Decision No. NYM/2022/0219

Please find enclosed 4 amendments we wish to make to drawing D11412-21E.

Photo 3.JPG

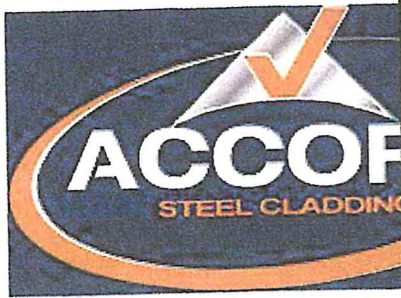
GREEN BOX PROFILE
CLADDING TO THE FLOOR
TO REPLACE
FAIRFORD
BLOCK WALLS.

PEDESTRIAN DOOR

34/1000 GRP Rooflight in P
add to basket
*To suit Accord

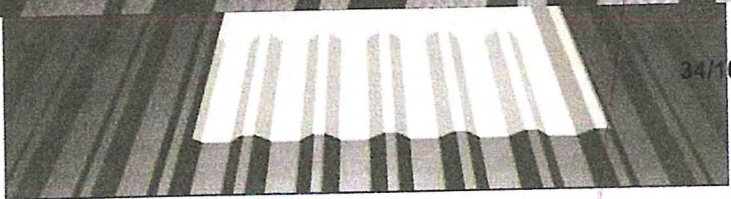
REPLACE SOME OF THE BOX PROFILE ROOF FROM GREEN TO SKY LIGHTS, SO THAT DURING THE DAY WE DONT WASTE ELECTRICITY WITH ROCKETING ENERGY BILLS.
